**PLANNED UNIT DEVELOPMENT****Date: October 20, 2016****DEVELOPMENT NAME**

**LOCATION**2955 and 2989 Dauphin Street  
(Southeast corner of Dauphin Street and Sage Avenue)**CITY COUNCIL****DISTRICT**

access between three lots.

Planned Unit Development Approval to allow shared

# SITE PLAN

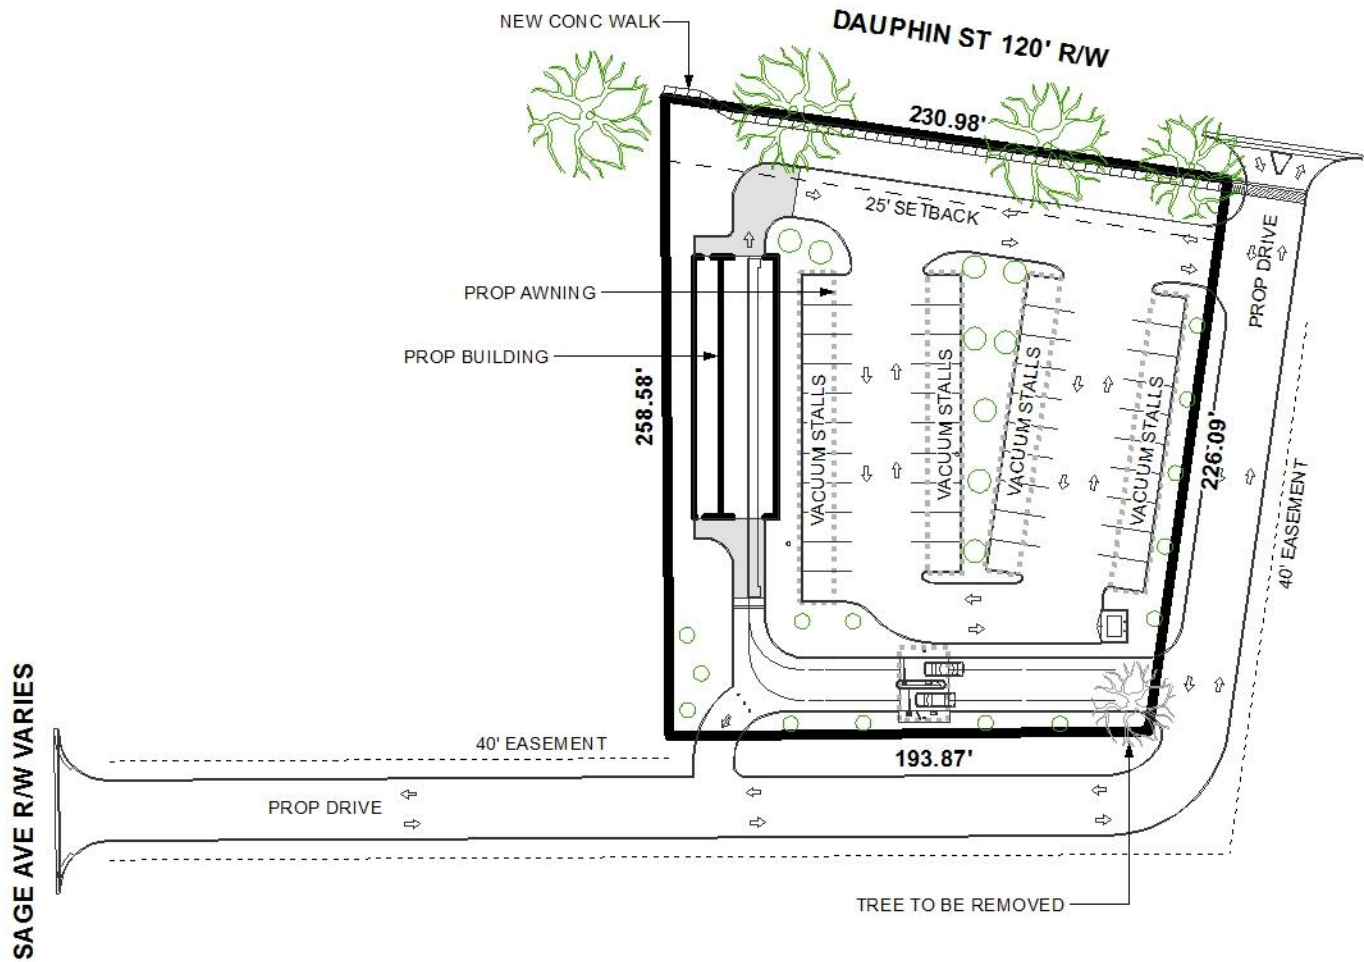
The site fronts Dauphin Street, a major street according to the Major Street Plan component of the Comprehensive Plan, with a compliant 120' right-of-way, therefore no dedication will be required. The site also has access to Sage Avenue via an access easement that will be constructed and used to connect to Dauphin Street. The site plan depicts the right-of-way width along Sage Avenue as varying, however, information on the Final Plat, recorded in 2008, shows the right-of-way as 60' from Sage Avenue. The site plan should be revised to depict the accurate right-of-way width along this portion of Sage Avenue.

The 25' minimum building setback line is depicted on the site plan for the lot being developed and should be retained on any future plans.

All proposed parking areas for the site appear to be compliant in terms of travel aisle width, parking stall dimensions, and number of spaces; however, it should be pointed out that the site plan does not depict any accessible parking spaces/ vacuum stalls, therefore the site is not in compliance with building code requirements. The site plan should be revised to depict compliant accessible parking, which may include the provision of one accessible parking space and one accessible vacuum stall.

A sidewalk is shown along the frontage of the site as well as proposed dumpster location. The illustrations should be retained on any revised PUD site plan, along with a note acknowledging compliance with Section 64-4.D.9. of the Zoning Ordinance regarding dumpster compliance.

The site plan provides landscaping information and illustrates tree plantings, however the required amount of frontage trees for the site appear to be short. After allocations for the canopy overhang have been taken in account for the existing live oaks within the right-of-way, the site is

still short 1 frontage tree. Adequate tree planting and landscaping for the remainder of the site is provided. A revised site plan depicting one additional frontage tree will be required. All revisions must comply with Section 64-4.E. of the Zoning Ordinance regarding tree and landscaping requirements.

In regards to the proposed car wash, full carwash compliance of the Zoning Ordinance is required. As such, all water run-off must be directed to the sanitary sewer system, an oil separator must be provided, and vehicles must be screened from view with at 3'-5' evergreen hedge and/or landscaped berm.

Lighting is not illustrated on the site plan. Any new lighting on the site will have to comply with the requirements of Sections 64-4.A.2., 64-6.A.3.c., and 64-6.A.8. of the Zoning Ordinance. A note reflecting this requirement should appear on the site plan, and photometric plans will be required at the time of submittal for land disturbance.

It should be pointed out that there was no signage information provided for the proposed site. The proposed development on Lot 2 will be limited to one freestanding sign and two wall signs.

- 1) Retention of the 25' minimum building setback line;
- 2) Retention of the sidewalk and dumpsters on the site plan, along with a note stating compliance with Section 64-4.D.9. of the Zoning Ordinance regarding dumpster compliance;

- 3) Retention of the right-of-way width along Dauphin Street;
- 4) Revision of the site plan to depict the right-of-way width along Sage Avenue;
- 5) Revision of the site plan to provide 1 additional frontage tree along Dauphin Street;

- 6) Site plan must meet full compliance of Section 64-4.E. of the Zoning Ordinance regarding tree and landscaping requirements;
- 7) Placement of a note on the site plan stating full compliance with the carwash requirements as stated in Section 64.12. of the Zoning Ordinance;

- 12) Submission of a revised site plan to Planning and Zoning prior to submission of land disturbance or building permits;
- 13) Submission of a revised site plan and photometric plan at the time of permitting depicting all proposed lighting, to comply with the requirements of Sections 64-4.A.2., 64-6.A.3.c., and 64-6.A.8. of the Zoning Ordinance.; and
